Product Support Bulletin 2008-005

Maintenance of Way ~ Work Equipment Bulletin

SUBJECT: Jaw Mounting Spacer Kit – 98410246

Figure 1
Jaw Mounting Spacer Installed on Spike Gun

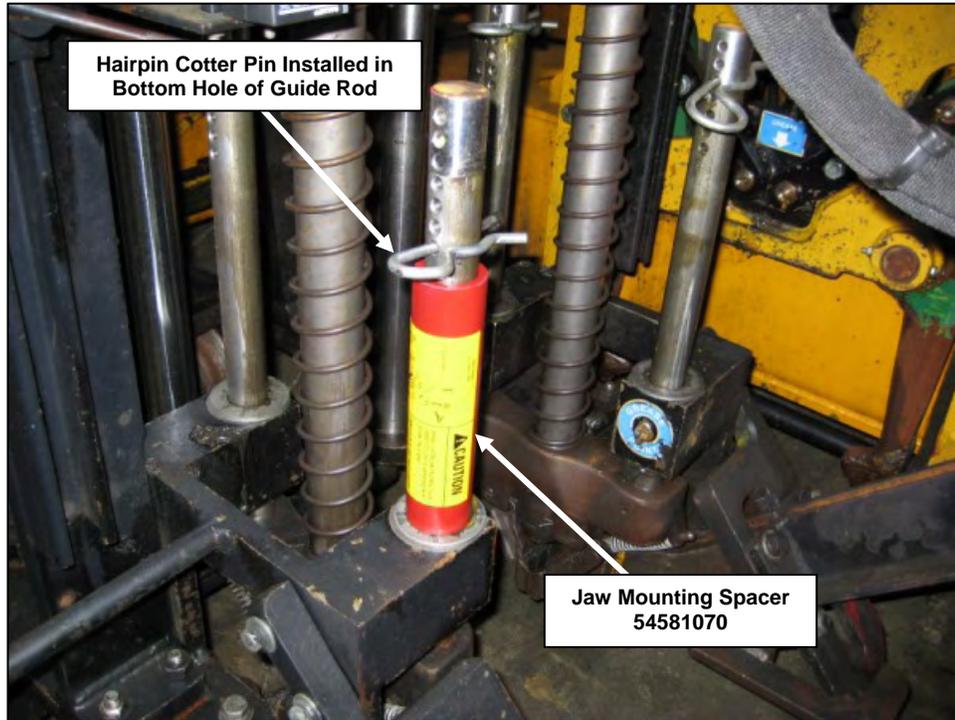
SUMMARY: When servicing the Anvil, it is necessary to lower the driving gun while keeping the spike jaws up to gain access to the Anvil Roll Pin. See Figure 1.

OPERATIONAL IMPACT: The 98410246 Jaw Mounting Spacer Kit is used to support the Spike Jaw Assembly when the driving gun is lowered and will make the job of changing the Anvil Tip, Anvil Roll Pin or Screw Spike Socket much faster and easier. When servicing the Anvil Tip, Roll Pin or Socket, the Hairpin Cotter Pin in the Jaw Mounting Guide Rod is removed. Then the Guide Rod Spacer is slid over the Guide Rod and the Hairpin Cotter Pin is reinstalled in the Guide Rod hole closest to the top of the Spacer. The Driving Gun can then be lowered to expose the Anvil or Socket Roll Pin. See Figure 1 on Page 2. It is recommended that the Hammer Override Button on the Hand Controller be used to lower the Driving Gun for service. **Be sure to follow all Lock Out-Tag Out procedures before servicing the Anvil or Socket.**

Figure 3
 Kit 98410246 Installation Instructions
 (CX Hammer, Model C Spiker, Two-Tie Screw Spiker, Production Screw Spiker Only)

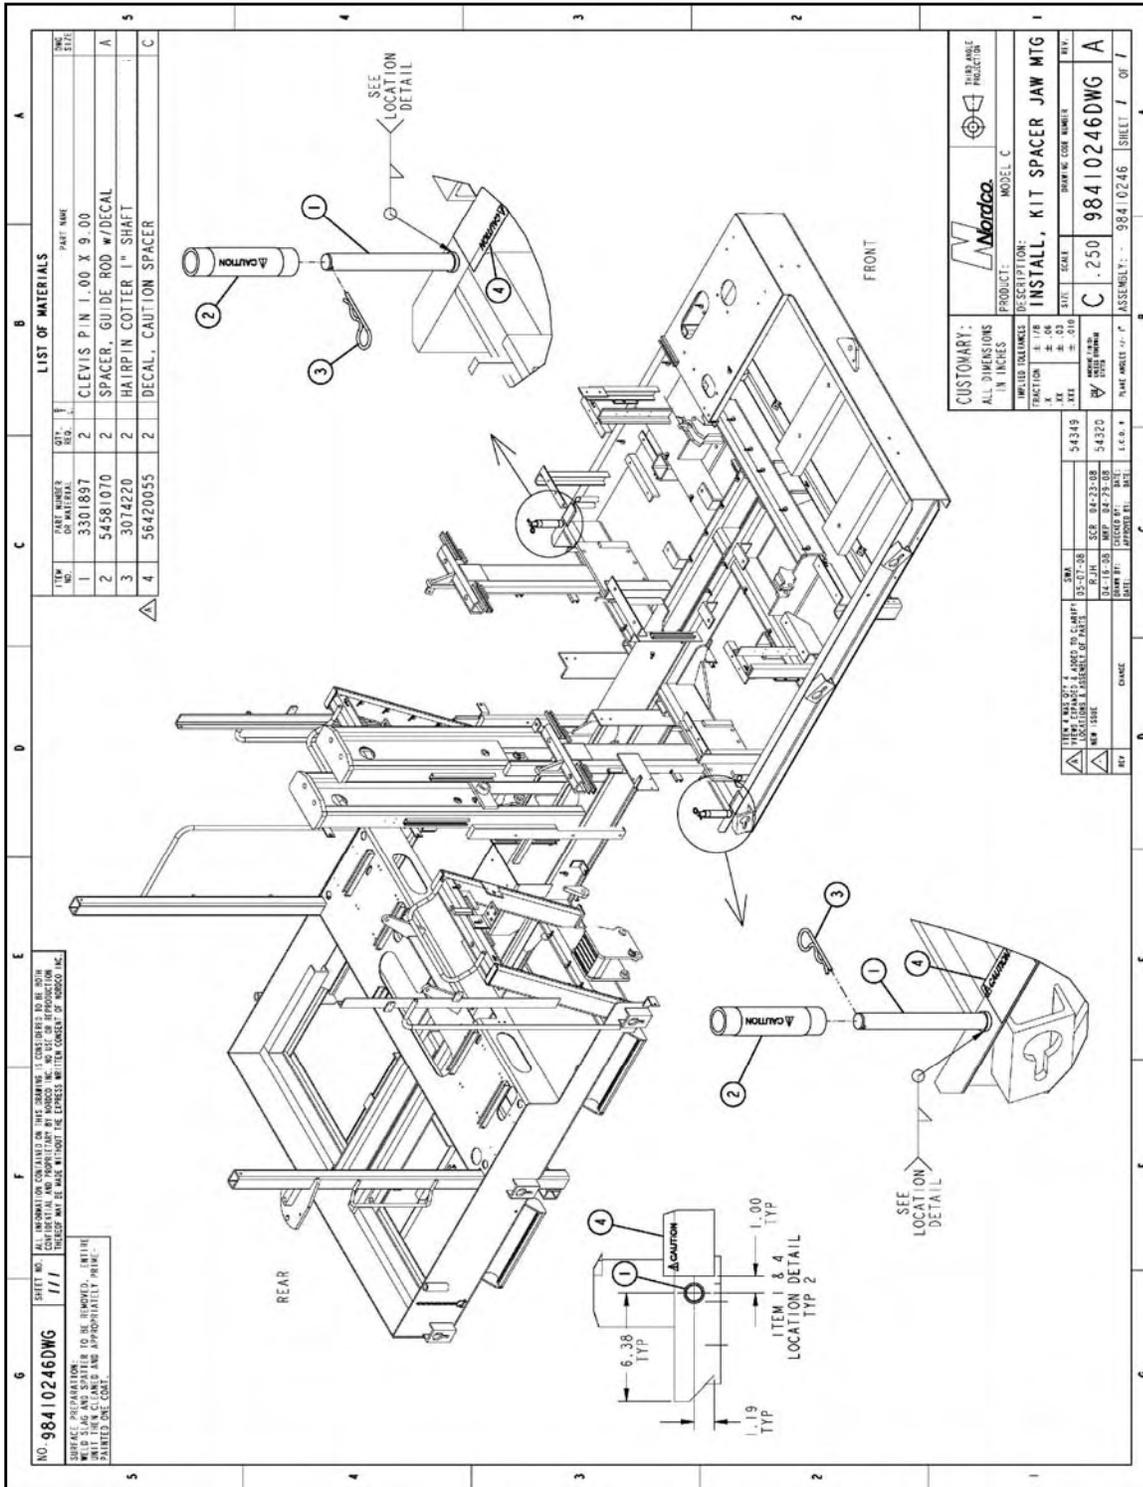
ACTION: The 98410246 Jaw Mounting Spacer Kit consists of 2 Spacers with Caution Decals, p/n 54581070, 2 Storage Pins, p/n 3301897, 2 Hairpin Cotter Pins, p/n 3074220, 2 Caution Decals, p/n 56420055 and installation instructions. See Figure 3 on Page 3 and Figure 4 on Page 4. The Storage Pins must be welded to each side of the frame and installation should take less than 30 minutes. Contact the Nordco Parts Department at 1-800-647-1724 to order. One kit is required for each machine.
